Service Bulletin

SUBJECT: Service Update for Inventory and Customer Vehicles
OnStar Microphone Quality
Expires with Base Warranty

MODELS: 2016 Buick Enclave
2016 Chevrolet Traverse
2016 GMC Acadia

Subject: 15663 – Service Update Bulletin
OnStar Microphone Quality
Expires with Base Warranty

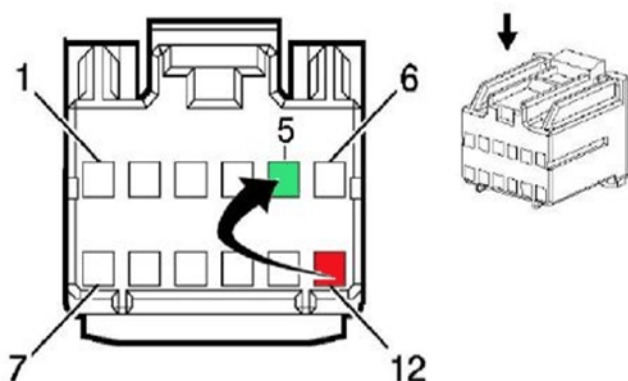
2. Remove the stowage compartment door.
